18-036MPR/WR/MSP – MCDONALD'S EXTERIOR, SITE MODIFICATIONS & SIGNS

Request

A request for review and approval of a Minor Project Review with Parking Plan, Waiver Review and Master Sign Plan for an existing McDonald's restaurant.

- **Ground Sign (1)**

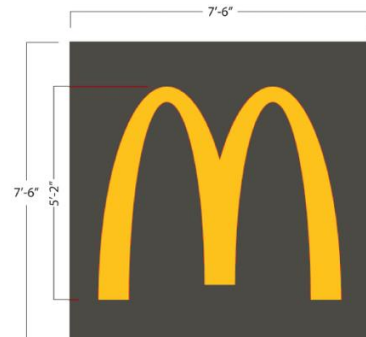
The removal of the existing pole sign is proposed. To replace the pole sign a new, architecturally integrated, modern monument sign with a neutral background is proposed. The sign base is masonry and coordinated with the building. The sign is a push-through acrylic letter with internal illumination. The sign design should be updated to provide 1.5-inches of dimension of the 'M' on both sides of the sign face. The applicant has considered the BSD Design Guidelines and character of the West Bridge Street corridor with their sign design.

The total sign area proposed is 56.25-square-feet and total sign height of 10-feet-11-inches. The area of the sign shall be reduced to 50-square-foot in size, and the masonry base shall not exceed 2-feet in height. The plans should be updated to reflect this prior to building permit submittal.

In all cases the ground sign must be located 8-feet from the right-of-way and every effort should be made to locate it wholly outside a utility easement subject to the approval of the City Engineer.

- 1) The height of both wall signs be reduced to 15-feet, as measured to the top of the sign;
- 2) The ground sign area not exceed 50-square-feet, the base not exceed 2-feet in height, and the sign design be dimensional with 1.5-inch relief on both sign faces;

- 3) The ground sign be a minimum of 8-feet from the right-of-way;
- 4) The applicant provide planting at the base of the ground sign, subject to Staff approval;

3. Site Plan

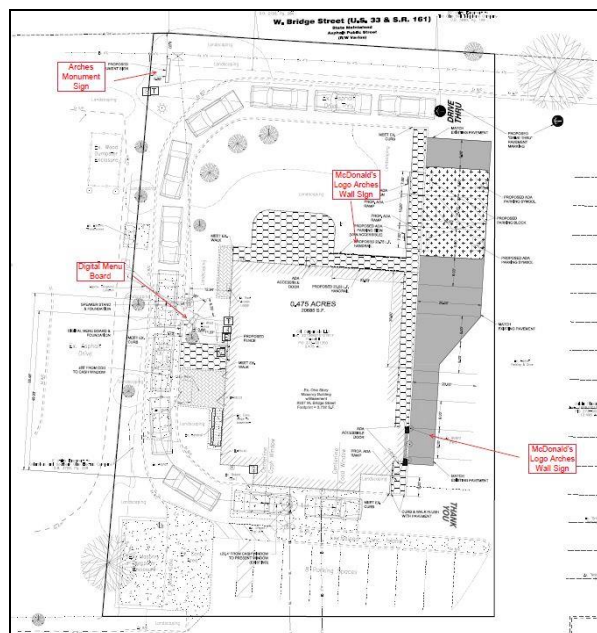
- c) **The application meets all applicable Zoning Code requirements.**
Criteria Met with Parking Plan, Waiver Review and Conditions. The proposed exterior and site modifications meet all Code requirements with approval of two waivers: 1) to reduce the minimum percentage of the building covered by a permitted material, and 2) to permit tile as a secondary material. The parking plan is to reduce the number of required spaces from 38 to 19. The applicant shall provide 4 bicycle parking spaces on-site. The applicant shall remove all uplit fixtures from the proposal. The applicant shall be required to ensure all window reflectiveness and glazing matches, subject to staff approval. The applicant shall updated the landscape plan to show the new ground sign location and landscaping. The applicant shall provide parking blocks where required.

- 1) The applicant updates the landscape plan to reflect the new plantings associated with the new monument sign;
- 2) The applicant provides the required number of bicycle parking spaces;
- 3) All the new windows meet the maximum reflectiveness permitted by Code and are non-tinted, and all old and new windows match subject to Staff approval; and,
- 4) The applicant eliminate all uplit light fixtures from the proposal.
